Subject: River Bend Station
Docket No. 50-458
License No. NPF-47
Supplement to License Amendment Request (LAR) 1999-30, "IFTS Blind Flange"

This letter provides supplemental information regarding License Amendment Request (LAR) 1999-30 and revises the proposed change to Technical Specification 3.6.1.3, "Primary Containment Isolation Valve (PCIVs)" related to the Inclined Fuel Transfer System (IFTS) Blind Flange. LAR 1999-30, as submitted by Reference 1, requested that the NRC approve and issue changes to SR 3.6.1.3.3 which currently reads, "Verify each primary containment isolation ... blind flange that is ... required to be closed during accident conditions is closed." Entergy requests that the proposed NOTE 4, as originally requested in LAR 1999-30, be revised to limit removal of the blind flange to 60 days, as follows:

Figure 1

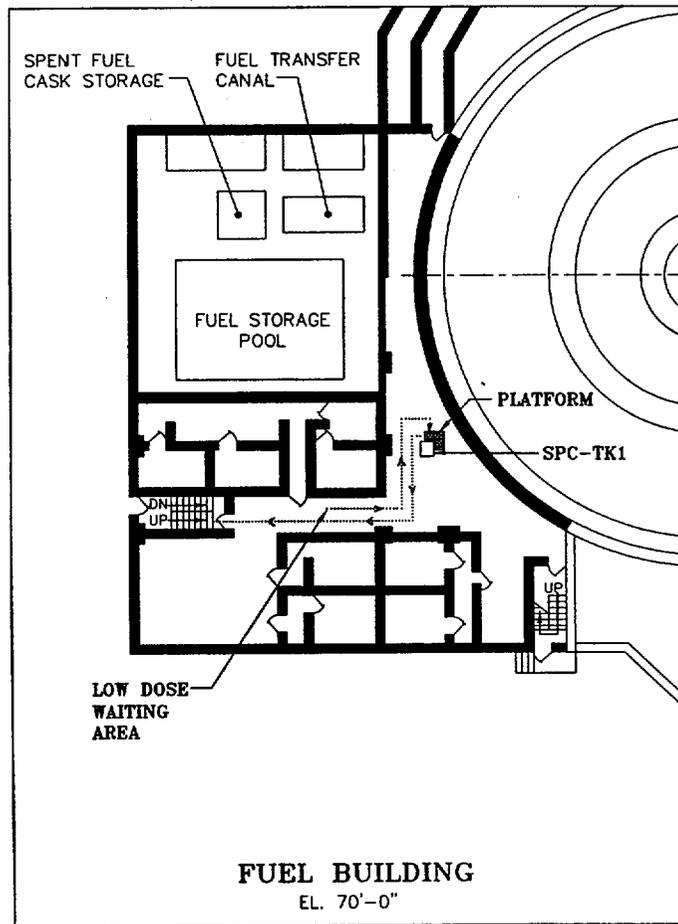
2. The operator will be staged in a low dose waiting area near the IFTS drain tank. The normal operation background dose rate is generally ≤ 2 mR/hr. The two isolation valves are accessible on the platform at the end of the tank itself. The staging area is denoted on the figure 1 below.

4. Upon isolation, the operator will egress the area by proceeding north, climbing the stairs, and exiting the Fuel Building through the door located roughly at lines plant FE and 5 (USAR Figure 1.2-20) and finally proceeding to either the Technical Support Center, the Main Control Room, or the exiting the plant entirely as directed by Operations. Figure 1 below shows the pathway within the fuel building.
